# A96 Threapland Junction Improvements Environmental Statement Addendum Non-Technical Summary

January 2009

This document is the Non-Technical Summary of the Addendum and should be read in conjunction with the original ES and Non-Technical Summary as the Addendum only addresses the changes to the original Scheme.

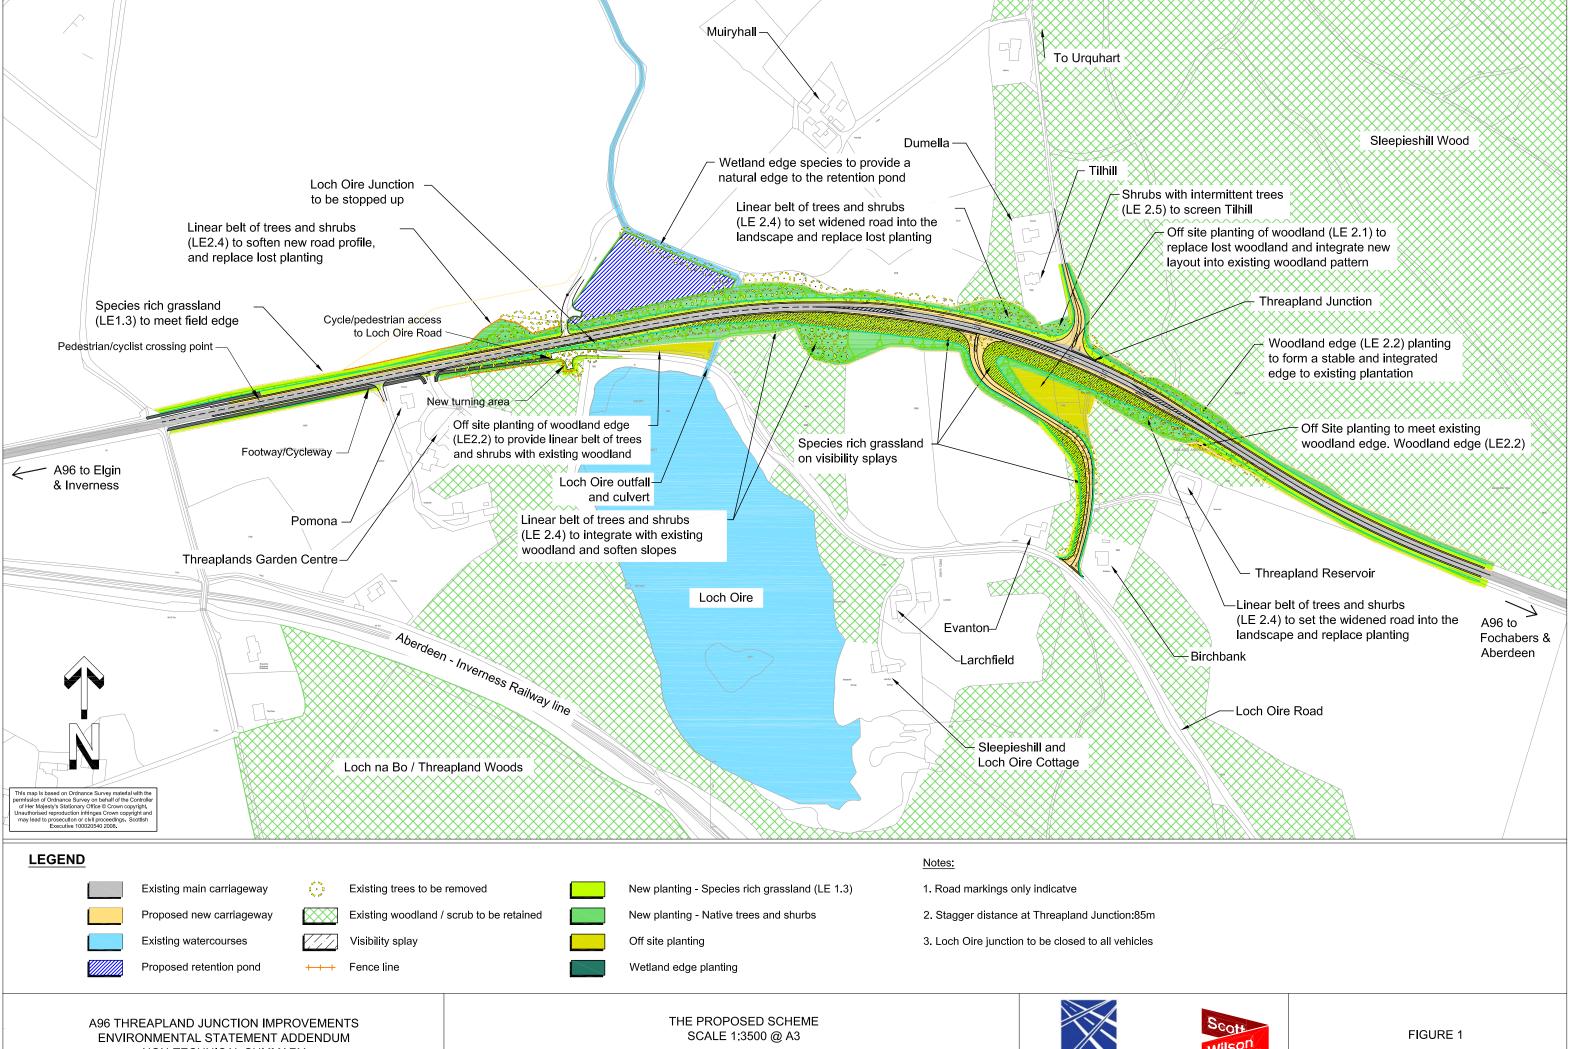
The Scheme has been slightly modified to ensure that no construction activity takes place

within the SSSI and in such a way that no additional landtake is required.

The changes to the original Scheme are described below:

The vehicle turning area situated at the west end of Loch Oire Road is to be relocated so as to avoid any encroachment into the Loch Oire SSSI. It will remain in compliance with Moray Council Development Control Guidelines. The turning area will be kerbed with all run-off from this area draining back towards Loch Oire Road which will subsequently outlet into Loch Oire Outfall Drain north of Loch Oire Road. This will prevent any run-off from entering the SSSI. The proposed cycleway alignment will subsequently alter slightly to accommodate this design change. The relocated turning area will result in the construction of an additional 50m<sup>2</sup> of carriageway compared to the original layout. However, this will also remove the need for approximately 140m<sup>2</sup> of cycletrack.

The southern section of the turning area will be approximately 1m above existing ground level which may require the construction of a small retaining structure. Should this be necessary, this will be provided in such a way so as not to adversely affect the appearance of the existing surroundings. Strengthened embankments will be constructed over a length of approximately 27m along the south side of the A96 in order to provide adequate area for construction of the Loch Oire Road vehicle turning area. The steepened embankment is not considered to pose any stability issues.
